MFN 06-262
Supplement 4

Subject: **Modified Reactor Building/Fuel Building Truncated Model,
SER-ESB-038 Rev. 5**

**Shimizu Engineering Report SER-ESB-038, Rev. 5,
“Modified RBFB Truncated FE Model Analysis Data,”**

Project	General Electric Company ESBWR Project	Shimizu Document No.	SER-ESB-038
Title	Modified RBFB Truncated FE Model Analysis Data	Rev.	5
		Issued Date	9/22/06
		Revised Date	1/9/07

Figure C-11 Element Forces Comparison NASTRAN to ANSYS (R1 Wall: Out-of-plane Shear [MN/m])

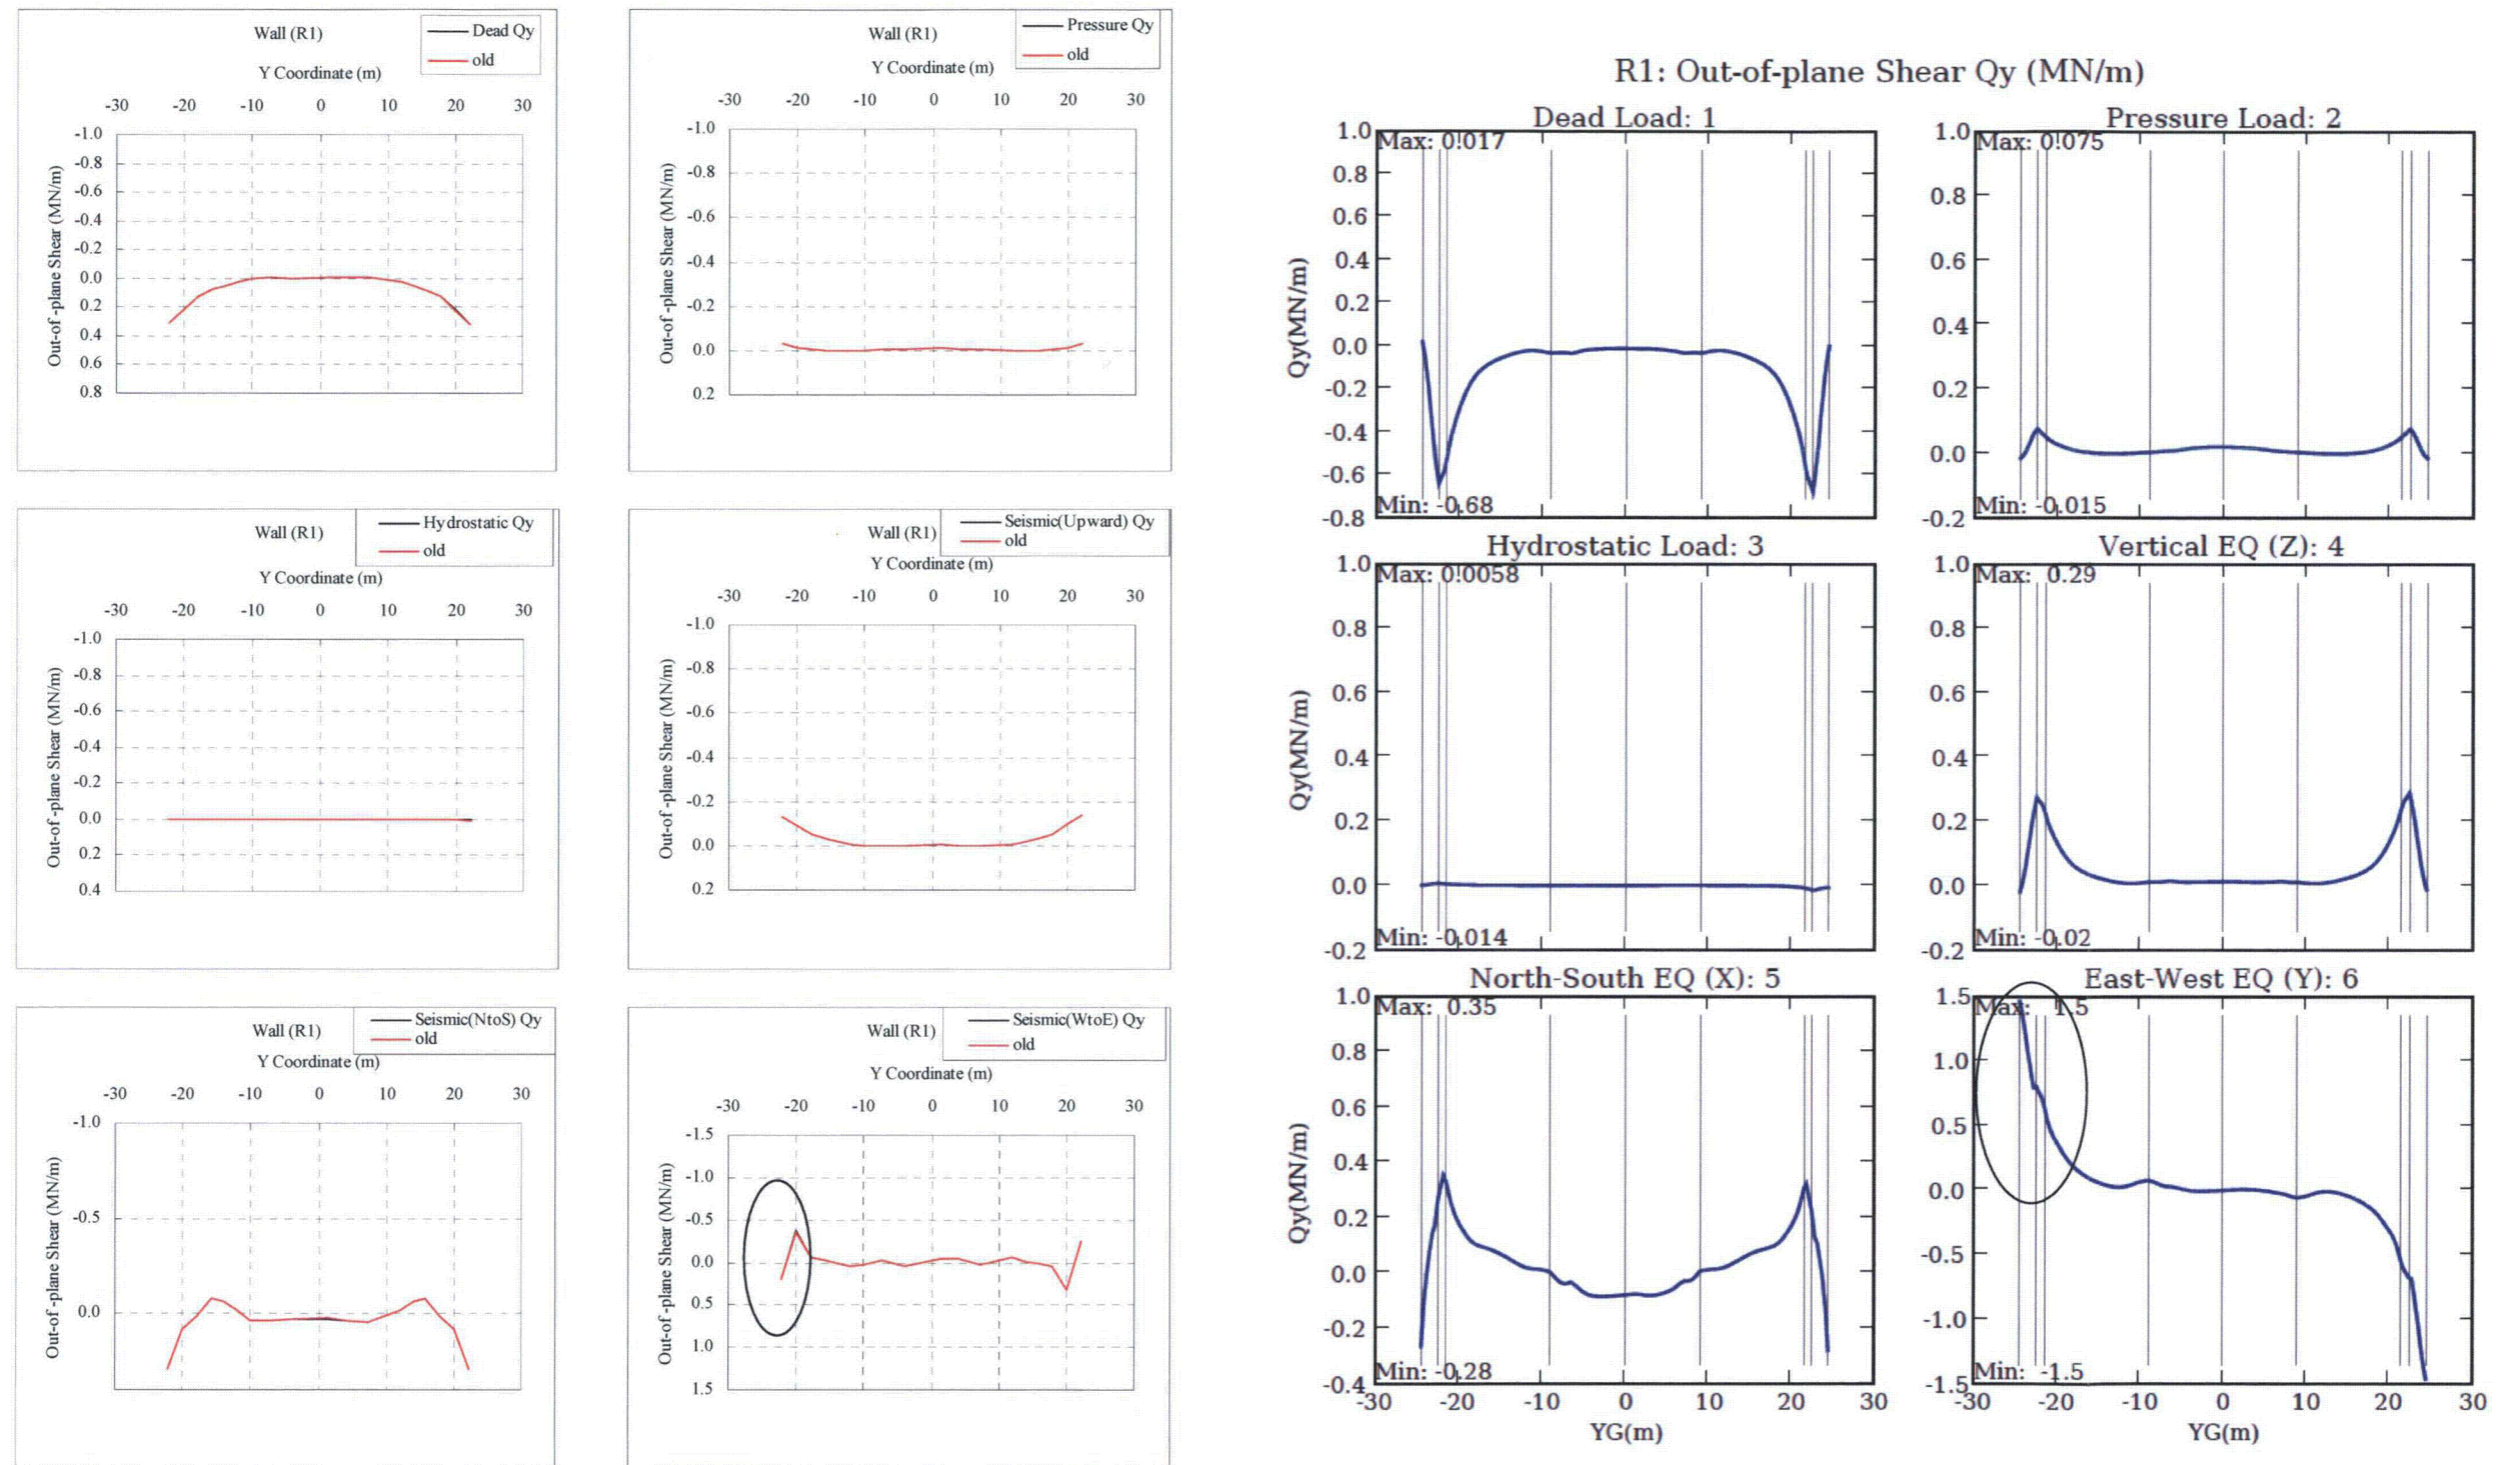
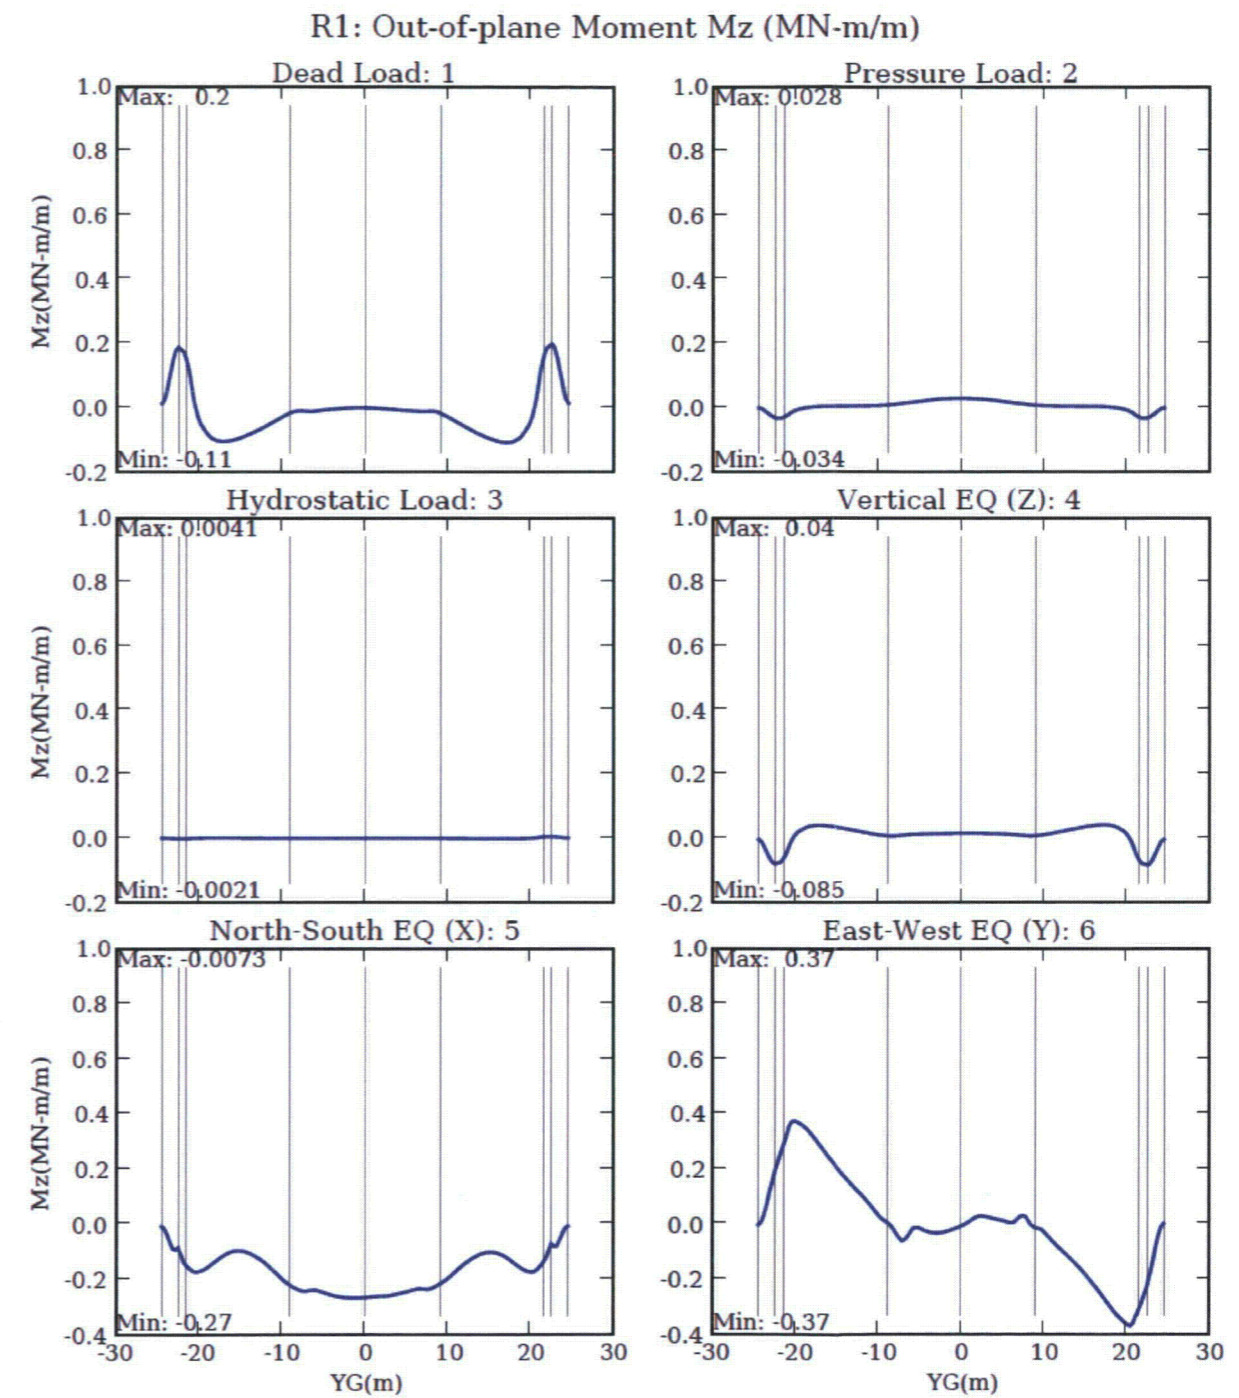
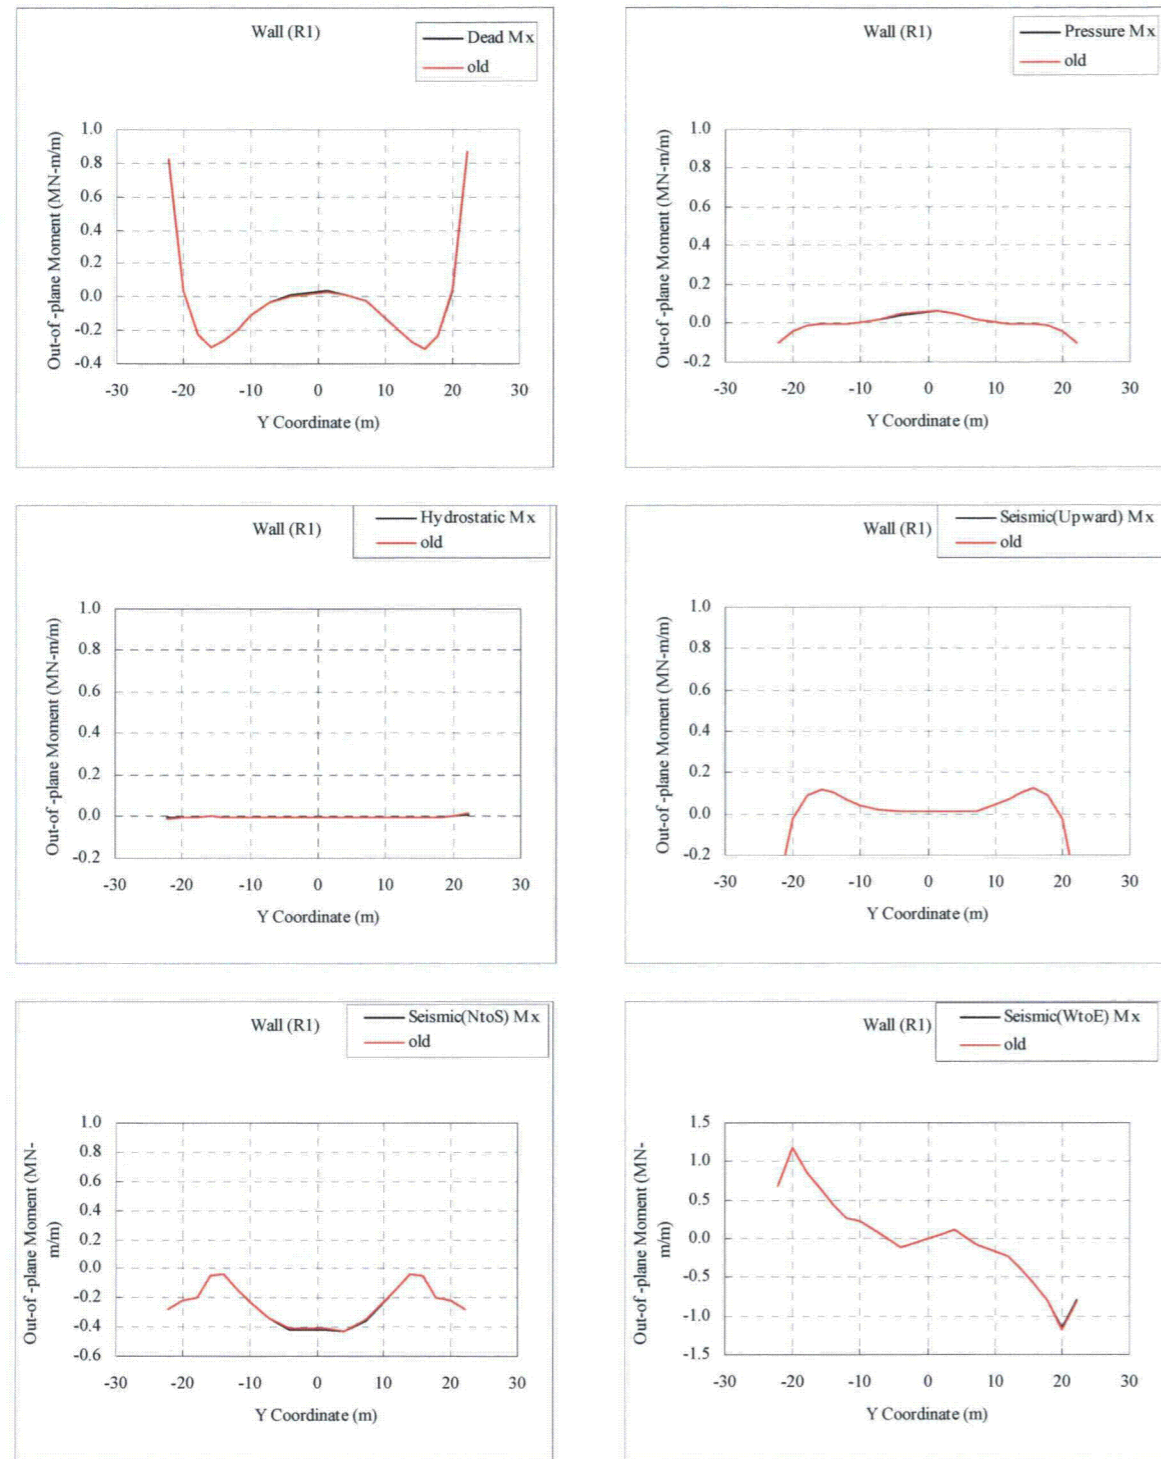
- iii) *The differences of magnitude of forces appeared on basemat inside pedestal:* The result of re-analysis using the updated model shows better agreement. In case of seismic load the magnitude of forces has to be re-compared because BNL's soil spring may not be adequate as pointed out above 3).

- iv) *The differences of magnitude of forces appeared on outer wall of Fuel Storage Pool (FSP):* For the out-of-plane shear forces and moments on RA and F3 wall located around FSP in case of Hydrostatic load, BNL's results are lower than those of GE. GE assumes the some part of differences comes from the difference of estimation levels between both models as pointed out above 8). In order to have a better understanding of the differences, GE would like to request BNL to confirm the input data for Hydrostatic load.
